ADDENDUM NO. 2

UTILITY INFRASTRUCTURE IMPROVEMENTS
WAPPAPELLO TRAINING SITE
WAPPAPELLO, MISSOURI
PROJECT NO.: T2213-01

August 18, 2022

SHEET TITLE:
**SITE
UTILITY
PLAN**

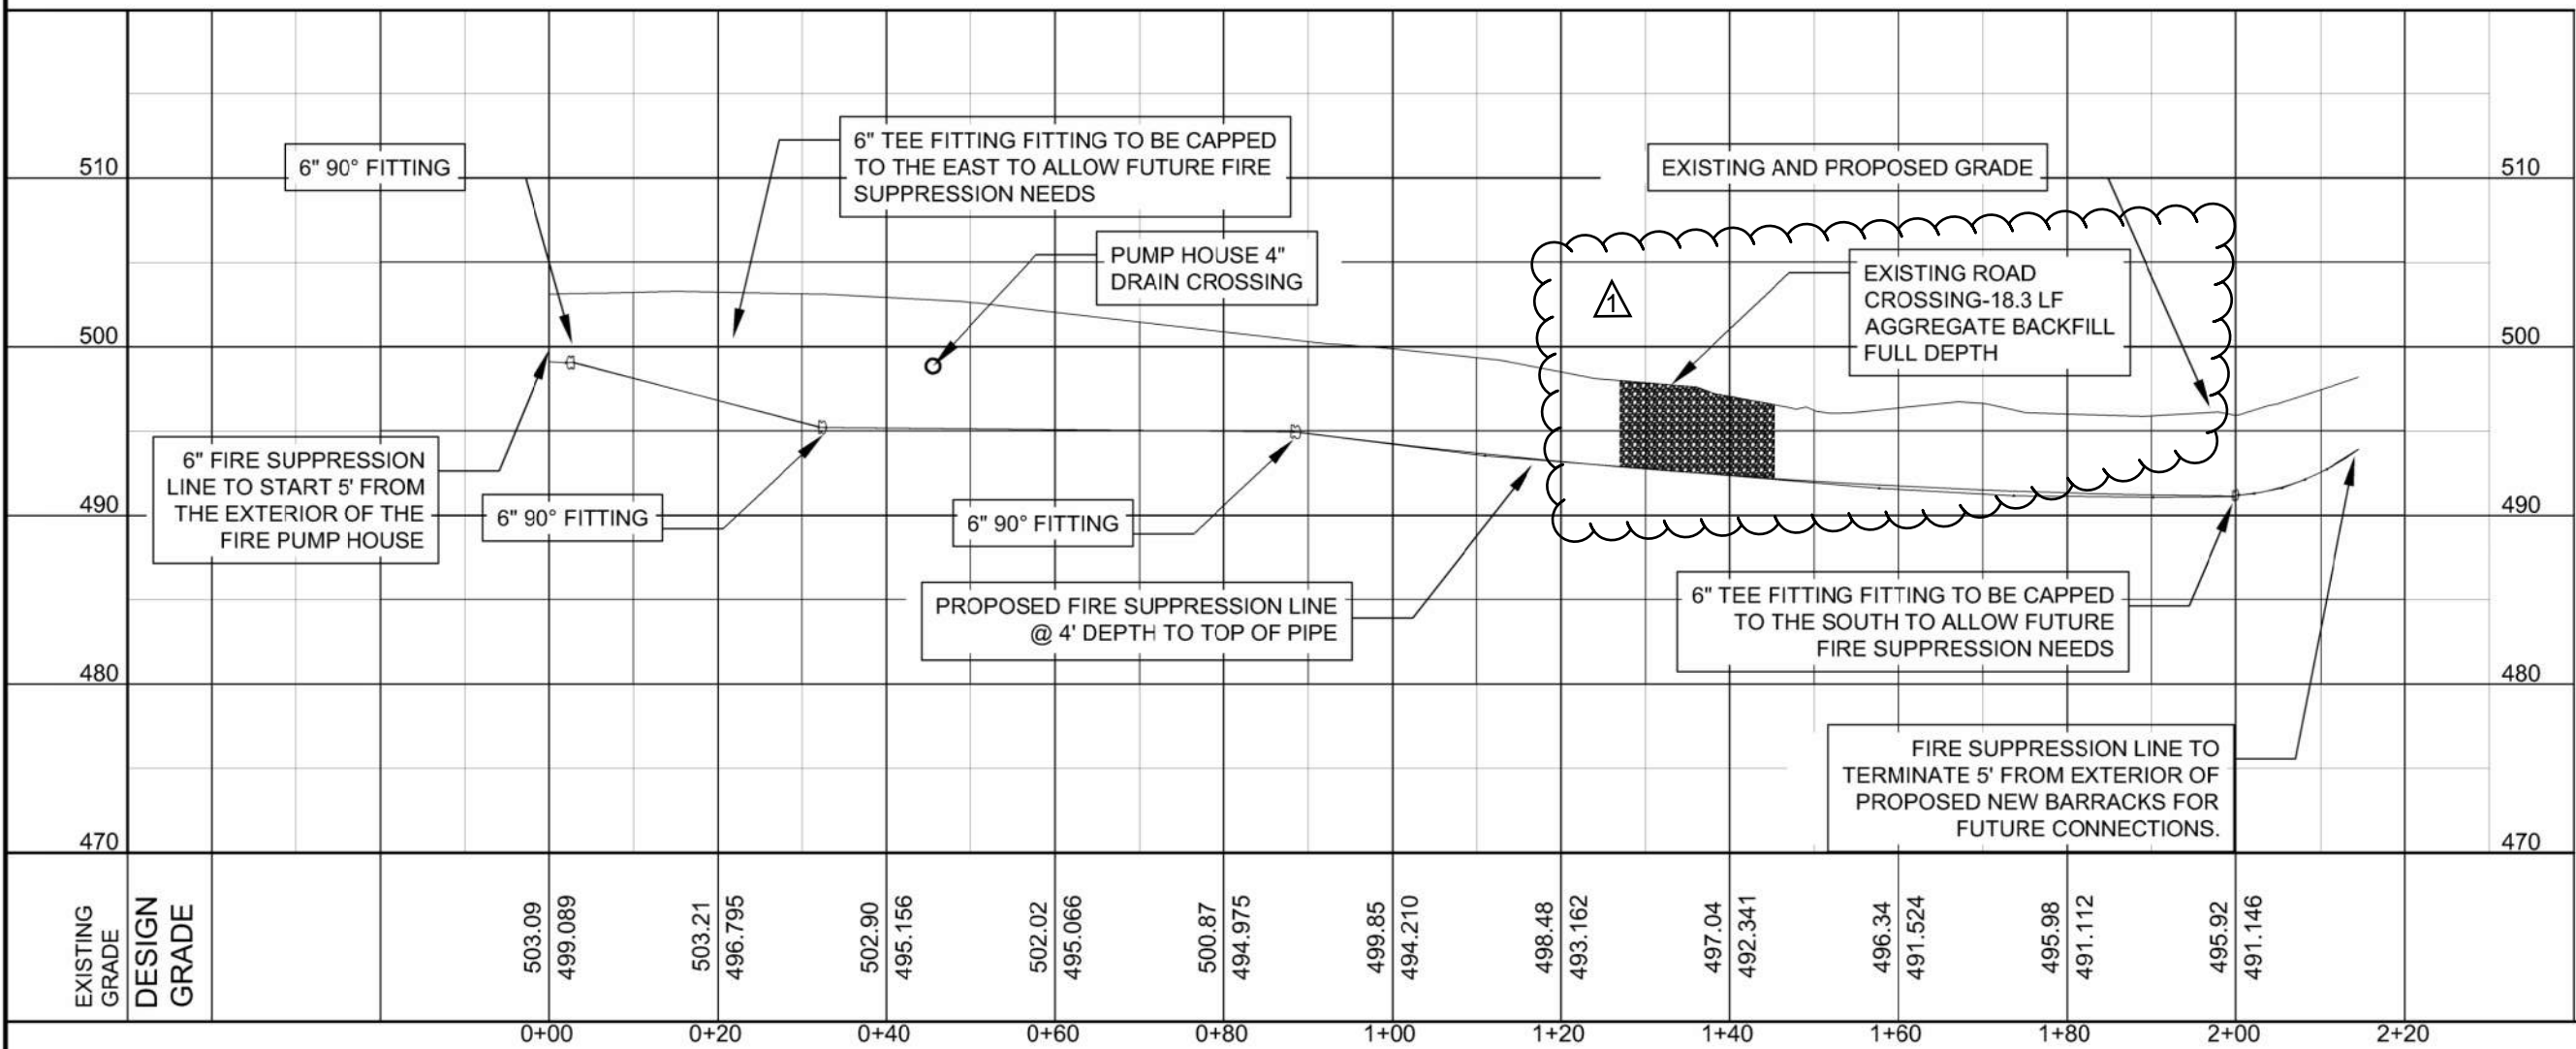
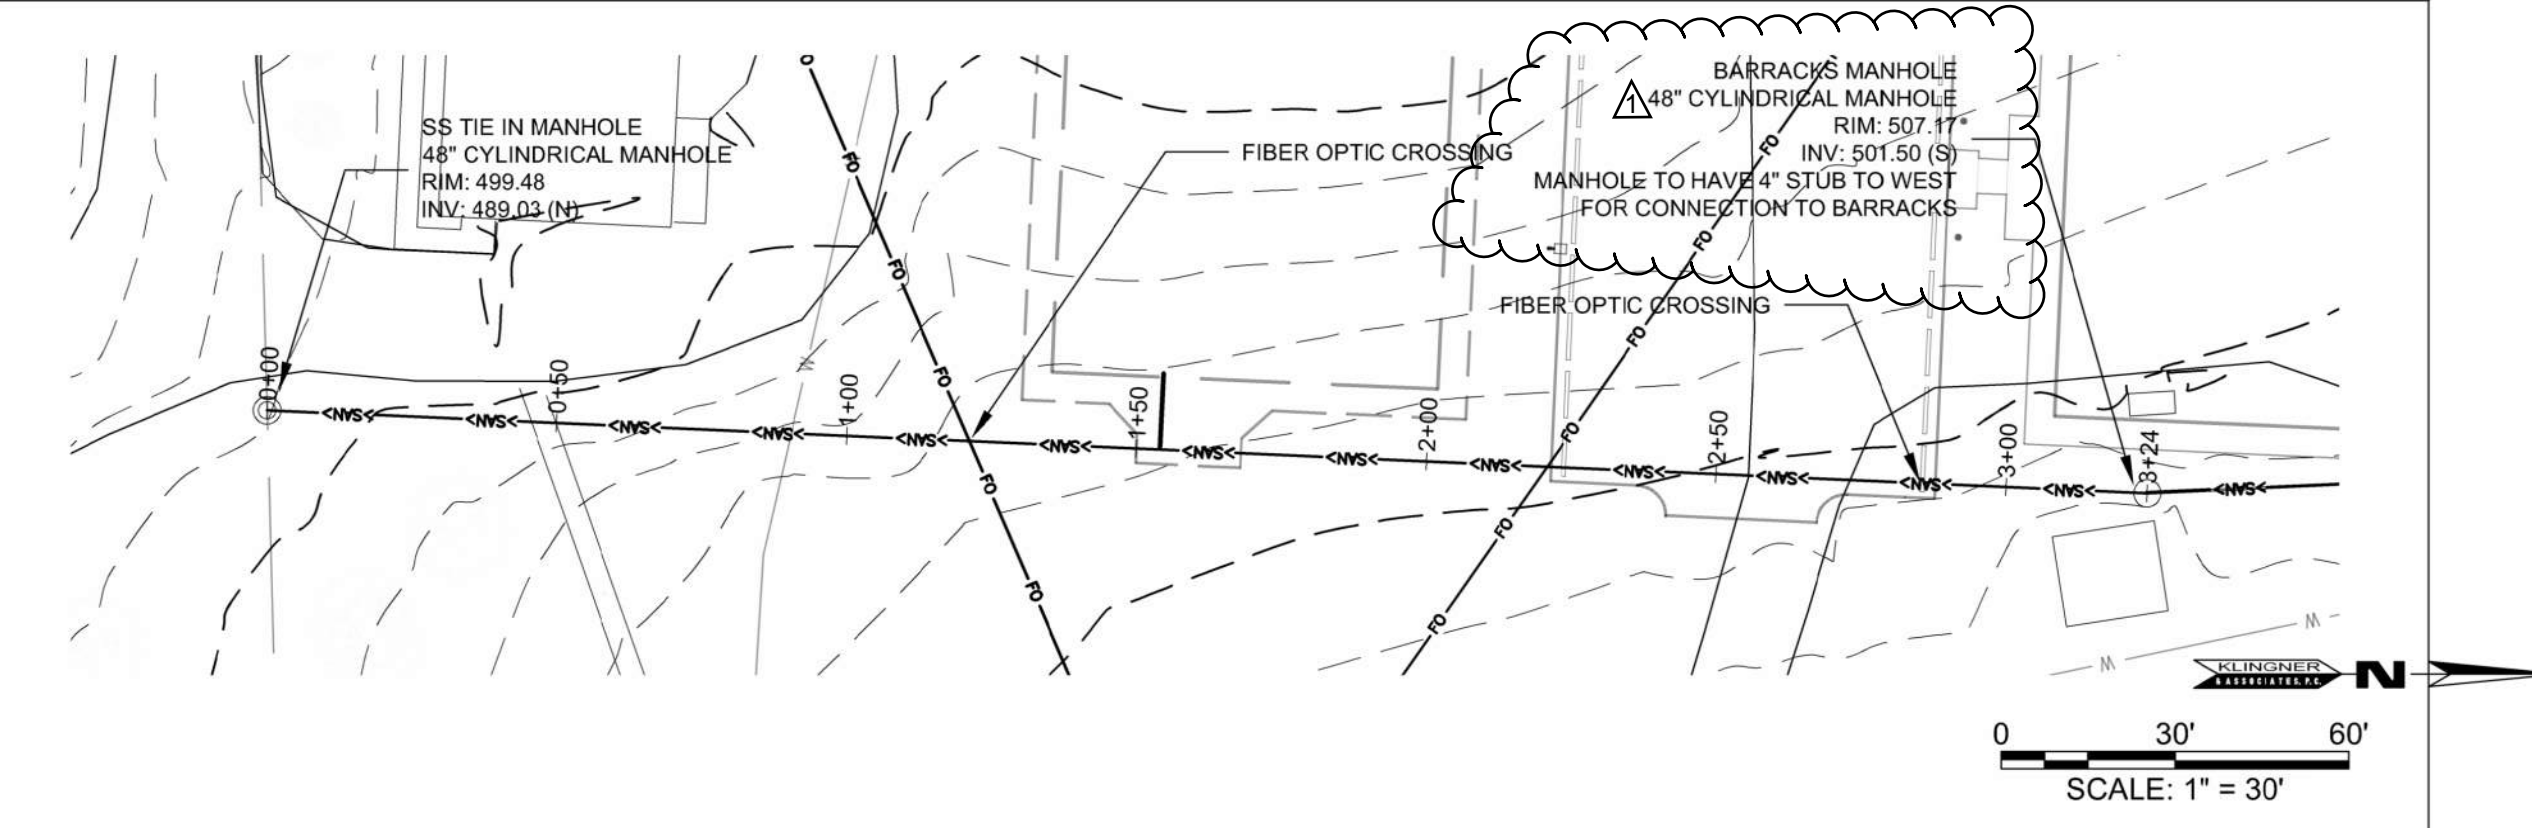
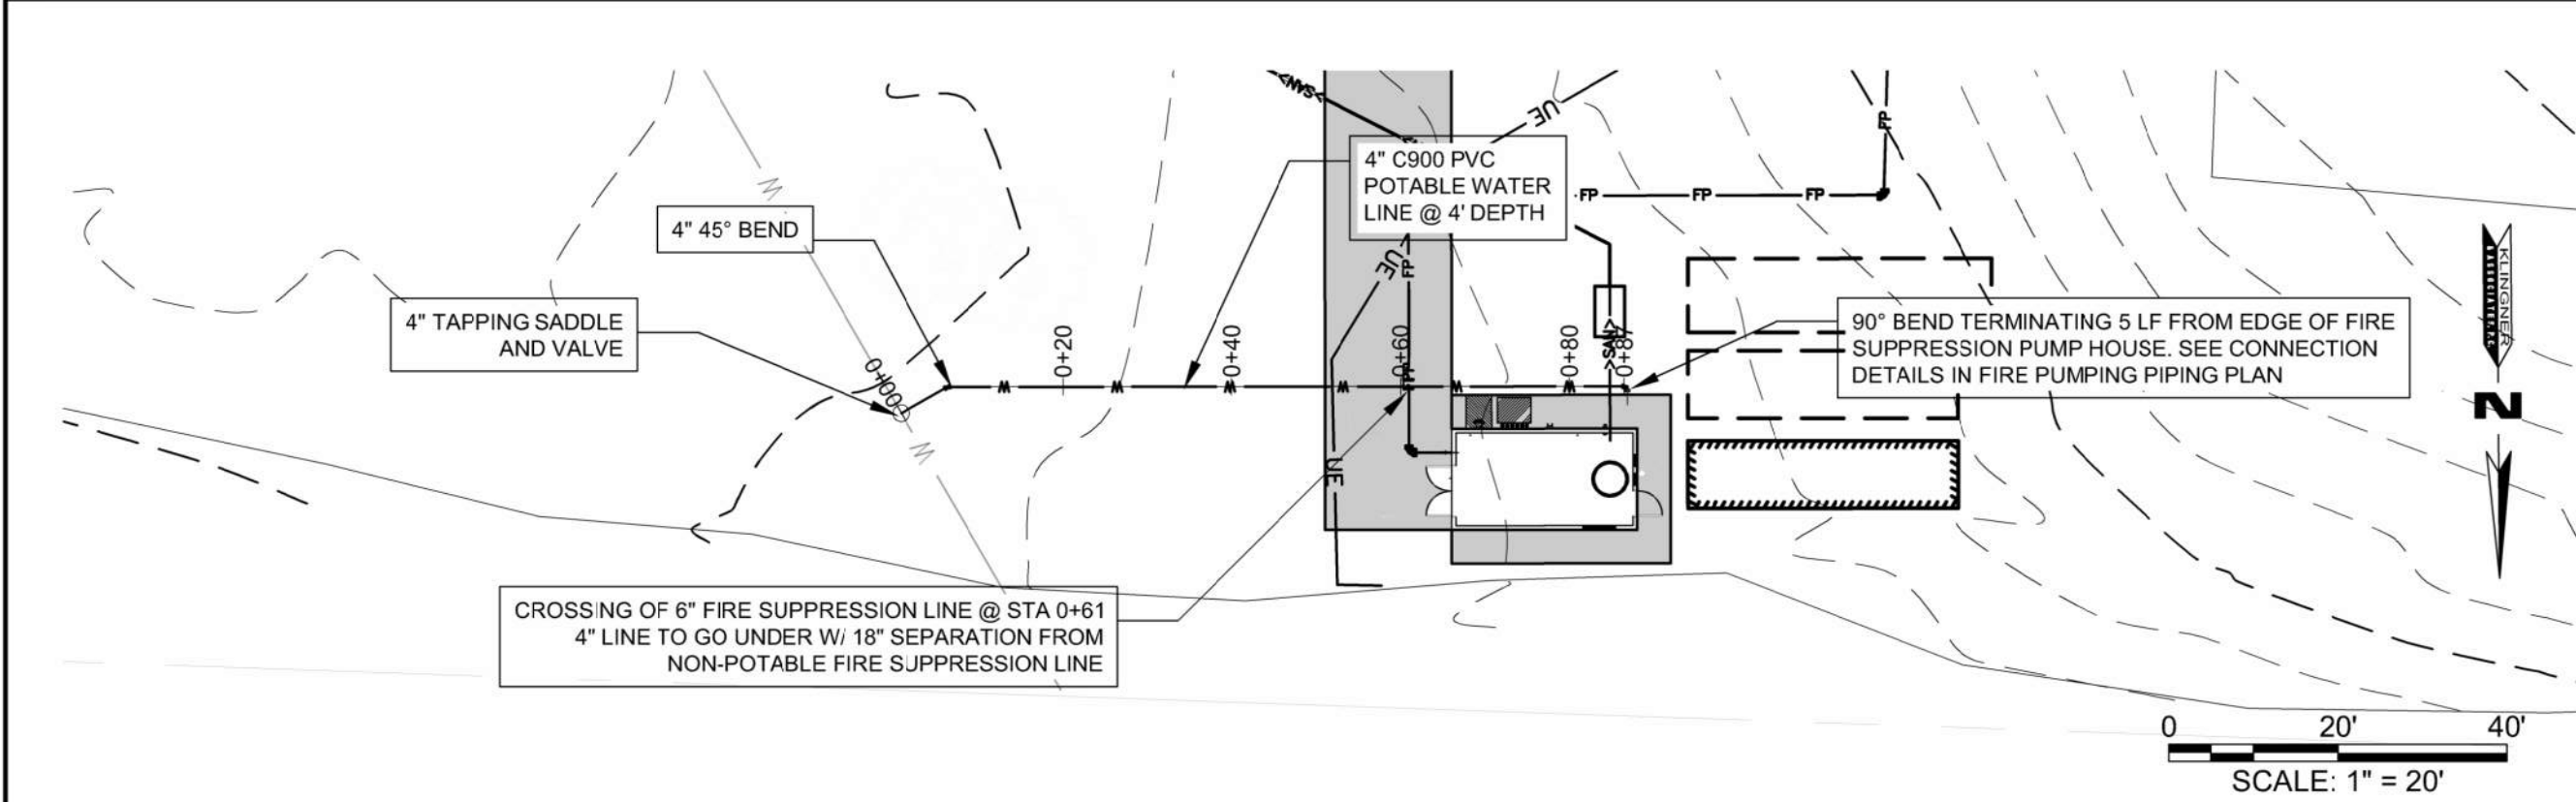
2. Sheet C102

ADD Note to profile at sanitary station 1+40 clarifying that aggregate backfill is required for full depth of trench at roadway crossing.

DELETE Notes requiring a flush hydrant and valving on the domestic water line.

ADD Note to require 4" sanitary stub on west side of the manhole at the proposed barracks building
